A96 Corridor Interim Report Phase Three

Water Supply

Rev	Date	Originator	Checker	Approver	Description
A	10/01/2007	C Smith / M MacNaughton	S Robertson	A Girvan	Issued to SW for comment

Figure 4: Demand on Existing Works from Inverness WSZ

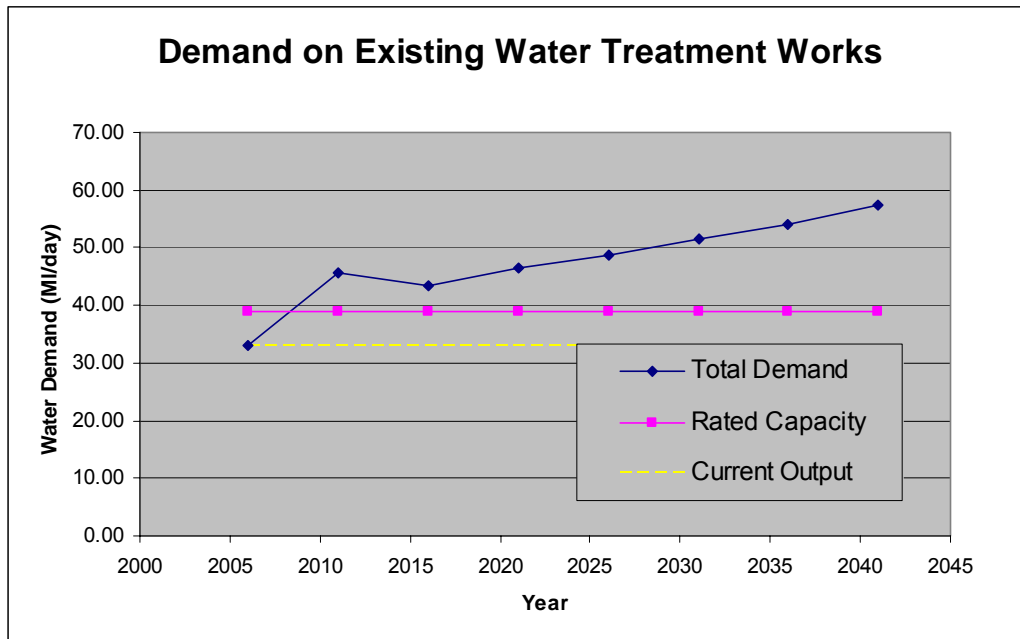
Comment: Was this done?
What was the outcome? Would do haven't
